Modification Bulletin

Project Name: Cherokee Hard Rock Casino 4 777 W CHEROKEE ST CATOOSA, OK 74344

Modification Bulletin No: 09

AV401 DRAWING NOTES

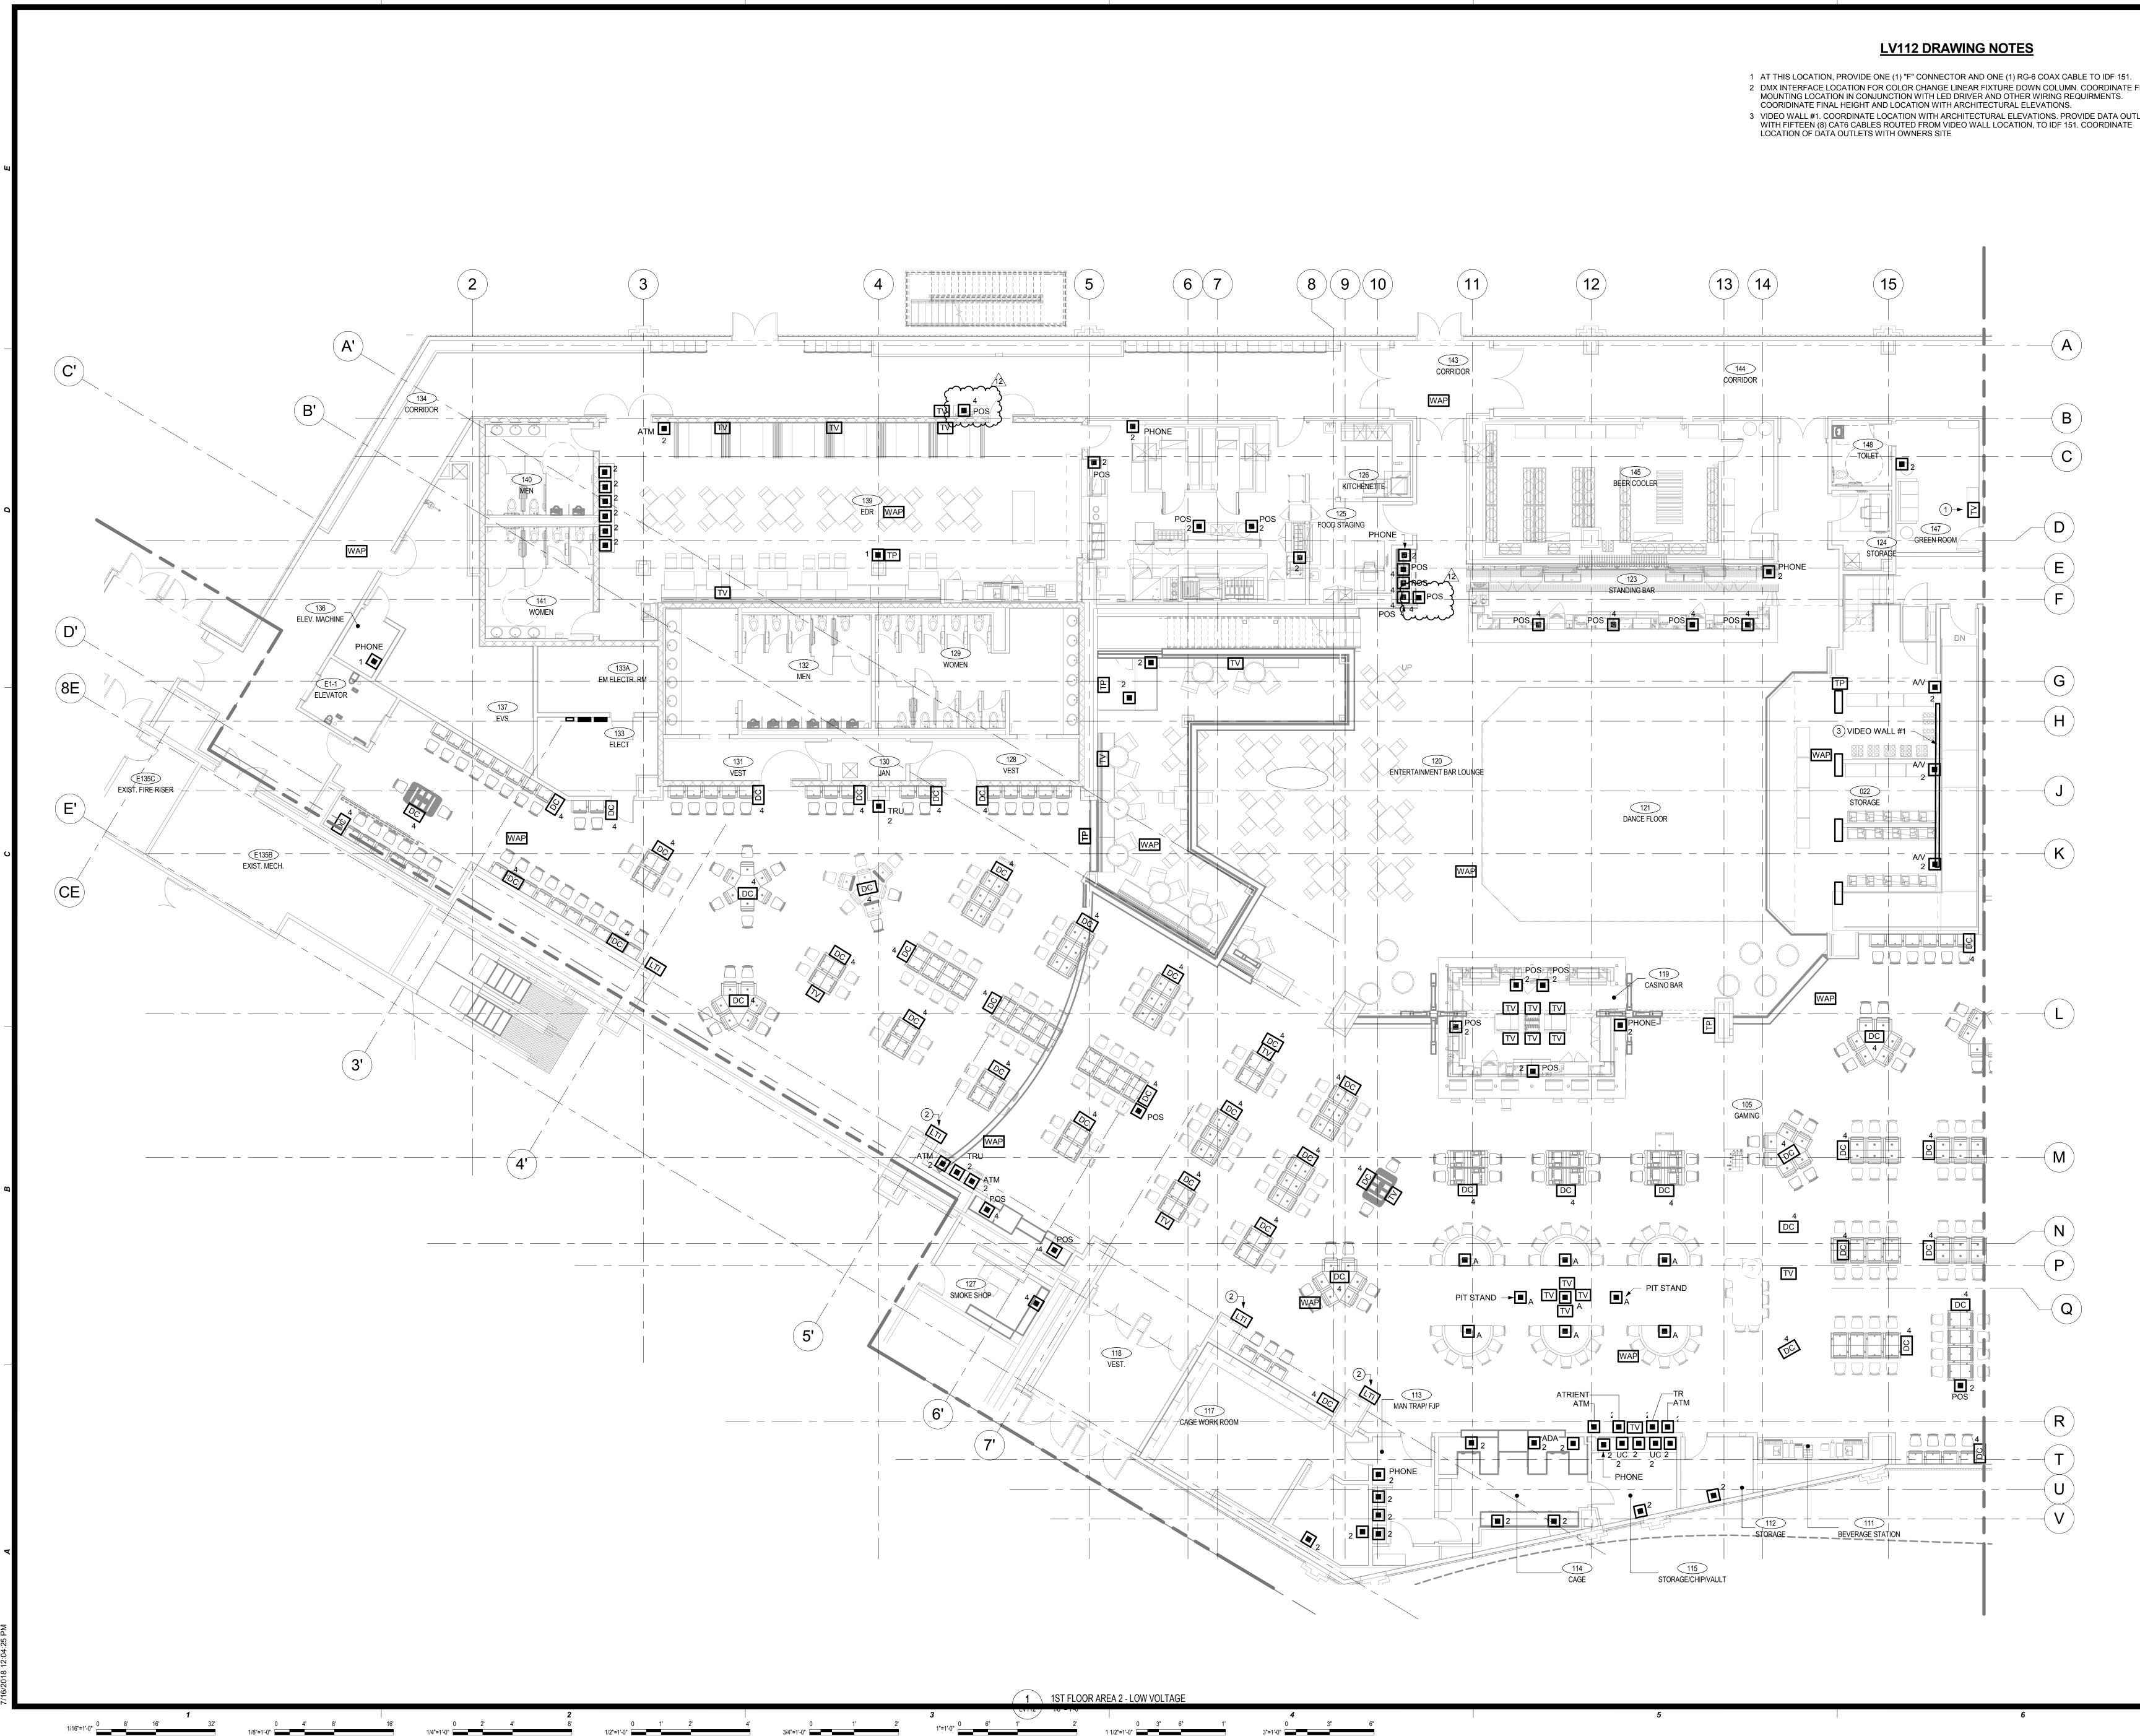
- A. <u>Refer to Drawing No. AV401</u>
 - 1. Revised stage equipment.
- B. <u>Refer to Drawing No. LV112</u>
 - 1. Revised data device layout.
- C. Refer to Drawing No. LV122
 - 1. Revised data device layout.
